June 30, 2006

Re: Cell 4A Lining System Design Report, Response to DRC Request for Additional Information – Round 2 Interrogatory, Cell 4A Design.

**SLOPE STABILITY ANALYSES
 CELL 4A – INTERIM CONDITIONS
 WHITE MESA MILL
 BLANDING, UTAH**

Figure 6. Water Content Versus Time for Samples of Gundseal Placed in Contact with Sand at Various Water Contents.

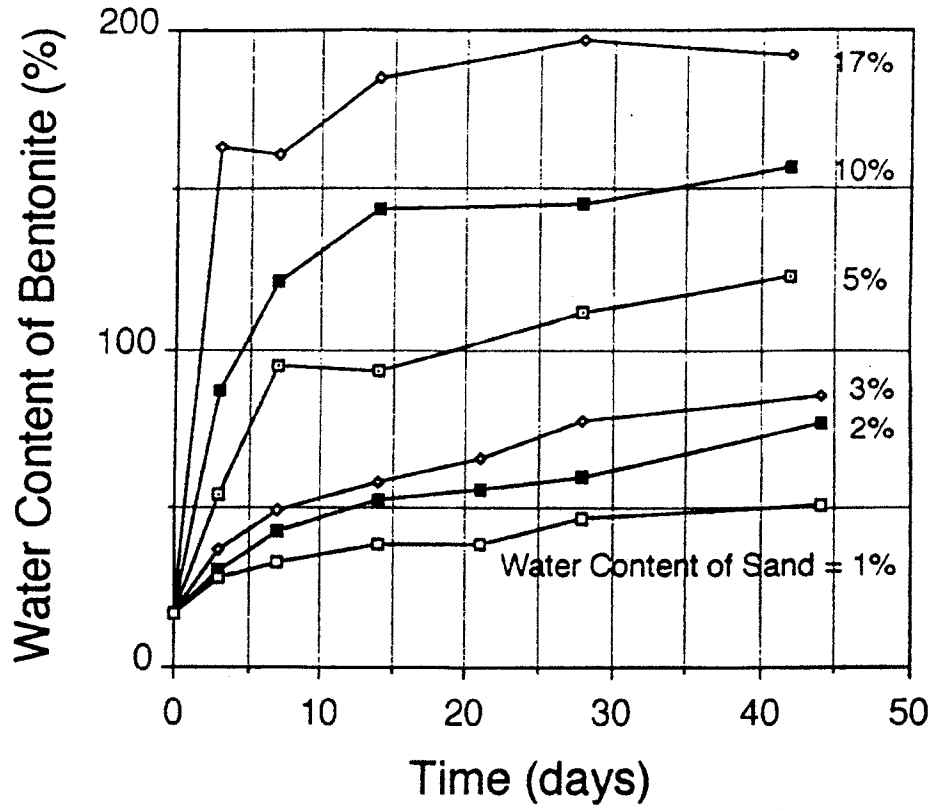
6. *Additional GCL Data – that the GCL will resist damage/degradation due to exposure to the leachate and freeze/thaw action. Include data on the hydration of the GCL and the potential impact of freeze/thaw on the GCL in the exposed portion of the liner system.*

The performance of the bentonite clay component of the GCL is derived from the ability of the bentonite to hydrate (absorb water). Bentonite clays have been shown to absorb water from adjacent soils with moisture contents as low as 1% (Daniel, et. al. 1992). Based on the construction records for the clay liner and dike construction (Appendix D of Design Report), the average dike soil moisture content was approximately 13.0% and the average clay liner soil moisture content was approximately 18.6%. As illustrated in Attachment A (Daniel 1992), a soil with a moisture content of 10% will allow the bentonite component of the GCL to reach a moisture content of approximately 140% at approximately 15 days. After

approximately 45 days, bentonite adjacent to soil with moisture content higher than 10% will hydrate to a moisture content of between 150% and 200%. Based on the construction schedule and the anticipated regulatory approval time, the GCL will be hydrated long before the cell is placed in service.

Figure 2

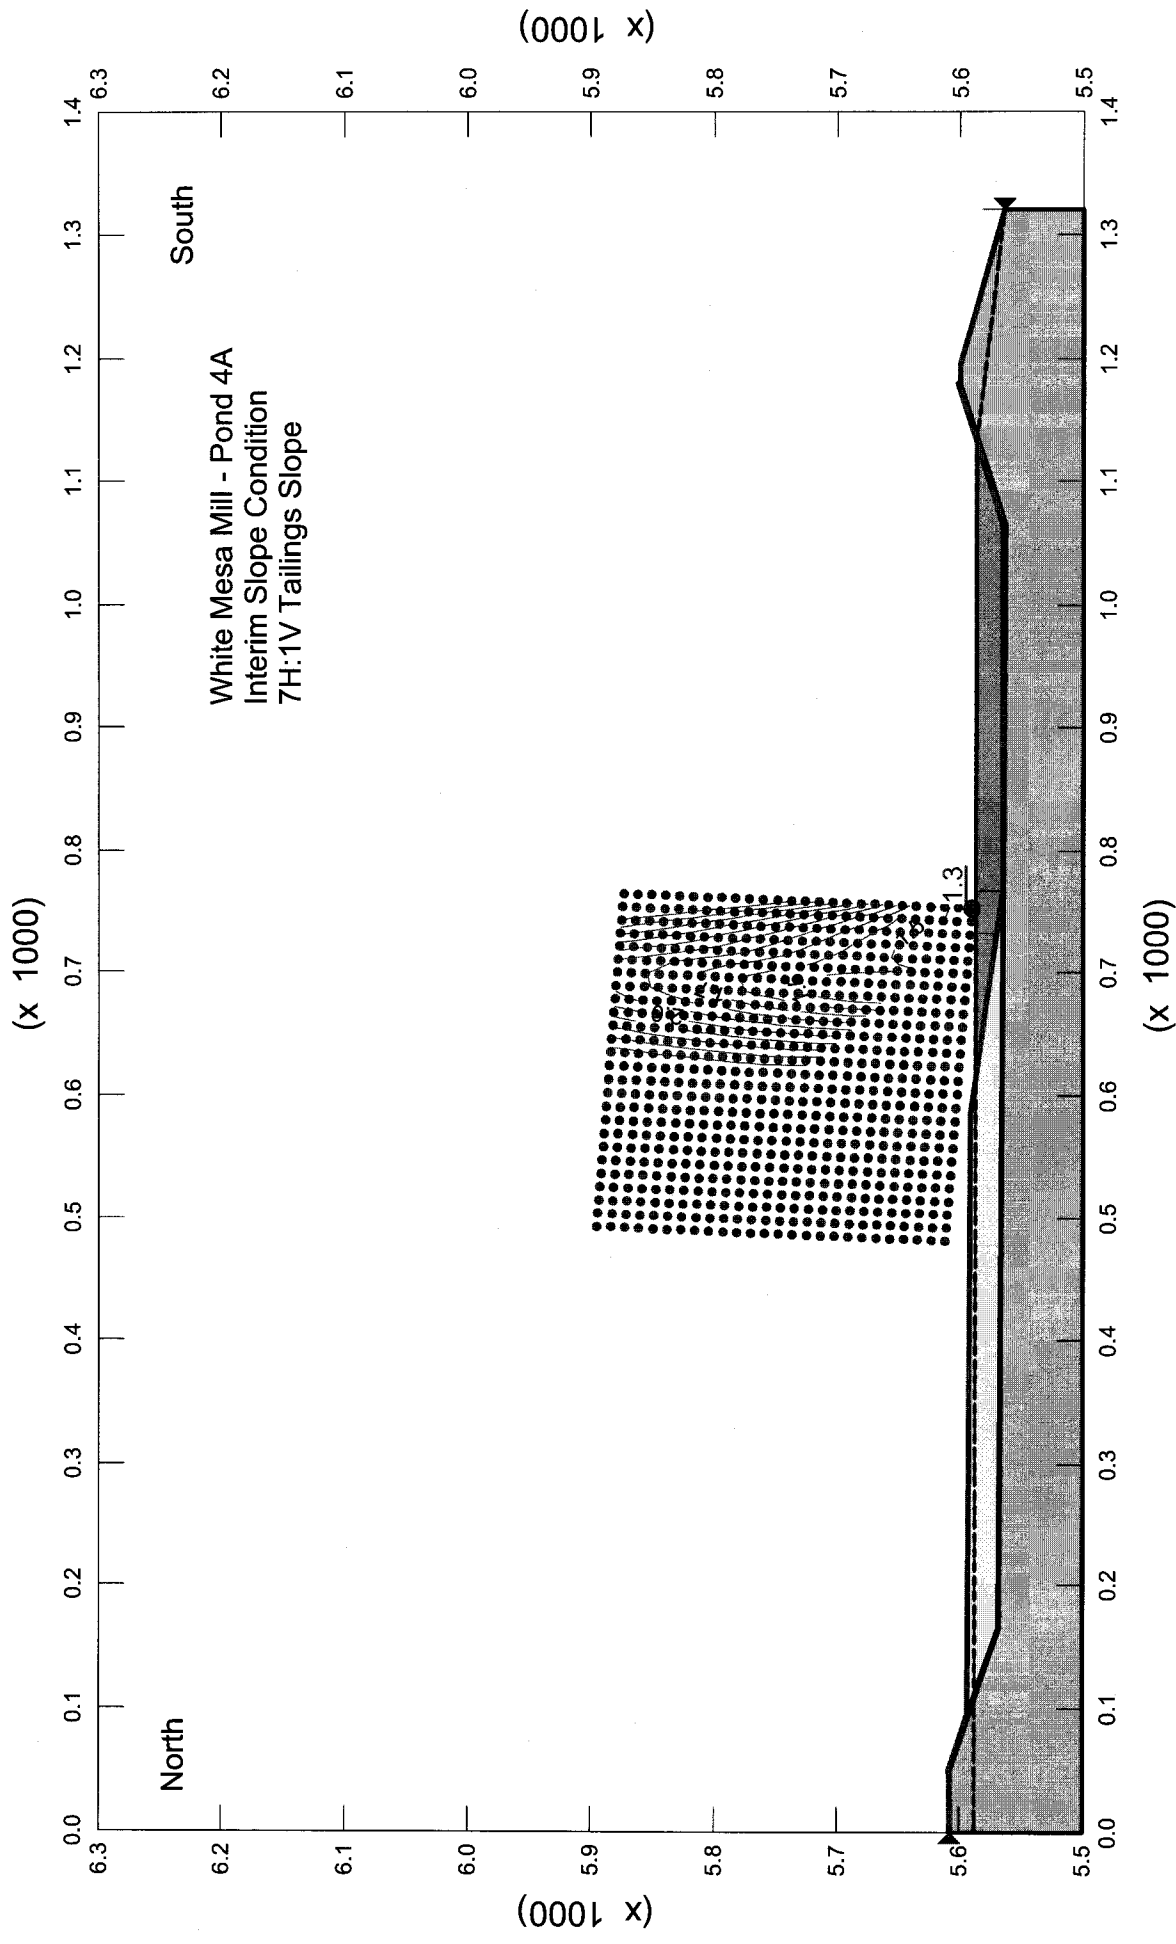
7. Construction and Operational Loading – Detailed procedures that cover installation of the cell and operation of the cell.

The tailings, consisting of medium to fine sands with silt and some clay, will segregate upon entering the liquids in the cell. The sands will drop out of solution soonest while the silt and clay fraction will be suspended longer and tend to drop out of solution further from the discharge pipe. Based on a review of existing operations in the existing cells at the facility, we have assumed the cell will be filled to approximately one-half of full height with liquids (approximately 20 feet) and that tailings may extend up to approximately 5 feet above liquid levels in the cell. In the modeling, the phreatic surface (liquid surface) is assumed to apply to only the waste and liner materials, since the composite liner system essentially eliminates infiltration of liquids into the underlying subgrade/foundation. Although tailings placed from a fluid deposition process are anticipated to develop a very shallow slope (i.e. beach) that is likely 10H:1V (Horizontal to Vertical) to 20H:1V or shallower, the analyses assumed a maximum slope inclination of 7H:1V. Based on these input parameters, along with the anticipated liner interface shear strength, a factor of safety value of 1.3 is obtained for a very small, shallow failure at the toe of the interim slope of the tailings. The slope stability analyses are presented in Attachment B.

Numerous potential failure surfaces were performed to evaluate various slip surface geometries and to identify the critical slip surface. The results of this analysis indicate a minimum static factor of safety of approximately 1.3 assuming waste slopes inclined at approximately 7H:1V, as

shown in Figure 2. This failure surface is a very small, shallow failure at the toe of the interim tailings slope. Much higher factor of safety values are obtained for larger failure surfaces.

We recommend that interface testing of the liner system be performed during construction quality assurance to verify that the interface friction angles used in this analysis for the liner system are met or exceeded. Further, we recommend that operations at the site limit the tailings/waste deposits slope to inclinations of 7H:1V or flatter.

SETTLEMENT EVALUATION OF BERMS

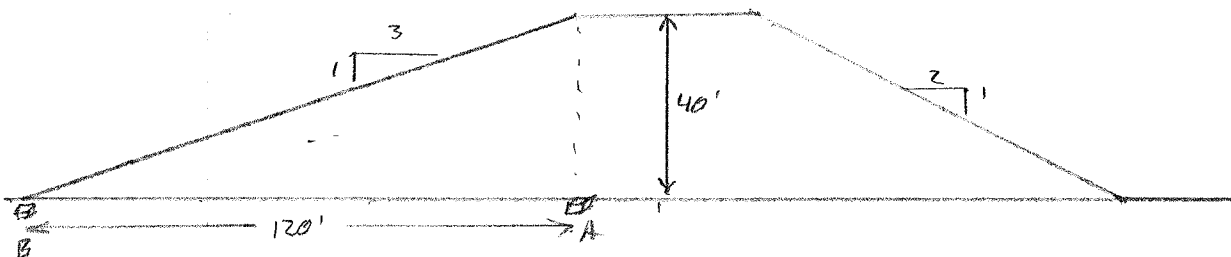
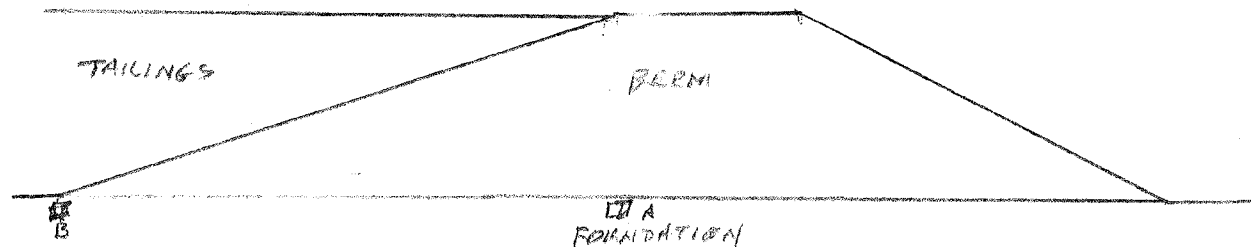
8. Settlement Evaluation – to evaluate anticipated settlement of the liner at the cell bottom and sideslopes under static conditions of the final cover system.

Cell 4A was constructed by removal of natural overburden soils and approximately 10 to 20 feet of undisturbed Dakota Sandstone upstream of the compacted fill creating the dikes. The majority of the Cell 4A tailings and cap material will be supported by the Dakota Sandstone formation, except for the small vertical component on the dike slopes. The estimated differential settlement of the dikes after placement of the waste materials within Cell 4A is approximately 2.4 inches from the top of the slope to the base of the slope. This value is conservatively estimated based on conservative modulus of elasticity values for the underlying materials. Based on this differential settlement, a potential strain of 0.16% will develop within the side slope liner system geosynthetic materials. This strain is well below the typical strain values that HDPE geomembrane, geonet, and GCL materials can withstand. The estimated differential settlement calculation is presented in Attachment C.

SETTLEMENT UNDER A = 4.4 in
 " " B = 2.5 in

$$\Delta S = 1.9 \text{ in}$$

$$\text{STRAIN IN LINER IS } \frac{1.9}{(126.5)(12')(\text{ft})} = 0.13\%$$

DIFFERENCE IN SETTLEMENT BETWEEN B AND A
 IS $8.45 - 6.01 = \underline{2.44 \text{ in}}$

STRAIN IN LINER $\frac{2.44}{(126.5)(12)} = \underline{0.16\%}$
